WELLAPINO. 30-015-32325
5. Indicate Type of Lease STATE ☒ FEE ☐
6. State Oil & Gas Lease No.
7. Lease Name or Unit Agreement Name PARKWAY STATE
8. Well Number 002
9. OGRID Number 162683
10. Pool name or Wildcat TURKEYTRACK;MORROW,NORTH

SUNDRY NOTICES AND REPORTS ON WELLS
(DO NOT USE THIS FORM FOR PROPOSALS TO DRILL OR TO DEEPEN OR PLUG BACK TO A DIFFERENT RESERVOIR. USE "APPLICATION FOR PERMIT" (FORM C-101) FOR SUCH PROPOSALS.)

2. Name of Operator
CIMAREX ENERGY CO. OF COLORADO

Operator: CIMAREX ENERGY CO. OF COLORADO 6001 Deauville Blvd Midland, TX 79706	OGRID: 162683
	Action Number: 379314
	Action Type: [C-103] NOI Plug & Abandon (C-103F)

PROPOSED

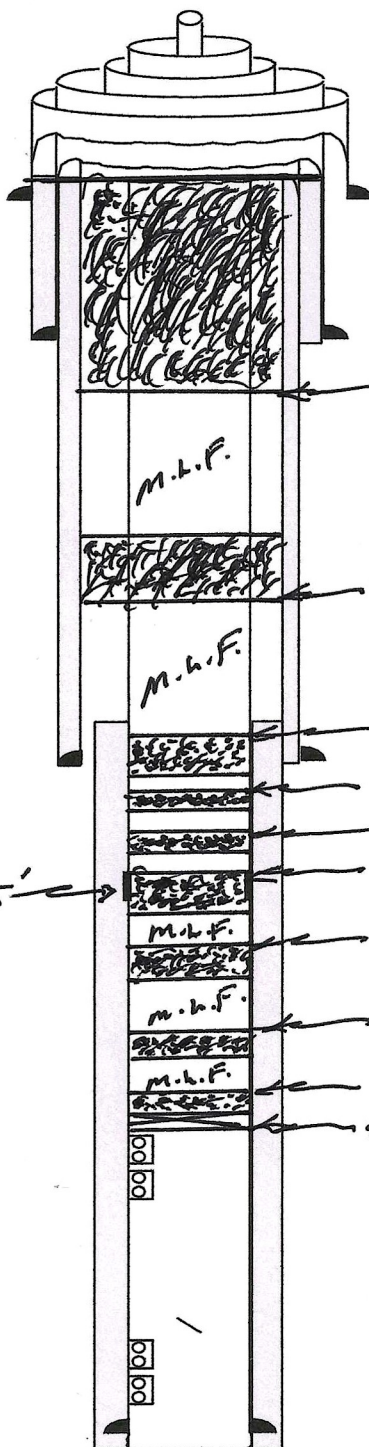
- Perf & sqz cmt 2220' - 2050' - T Queen
- PERF. X ATTEMPT TO SQZ. (6) SXS. CLASS "C" CMT.@ 1,570'-1,460' (T/YATES); Woe X TAG TOC.
- PERF. X CIRC. TO SURF., FILLING ALL ANNULI, (125) SXS. CLASS "C" CMT. @310'-3'.

MUST BE PLUGGED BY 8/1/25

Created By	Condition	Condition Date
gcordero	CBL must be submitted to OCD via OCD Permitting prior to submitting C-103P	8/30/2024
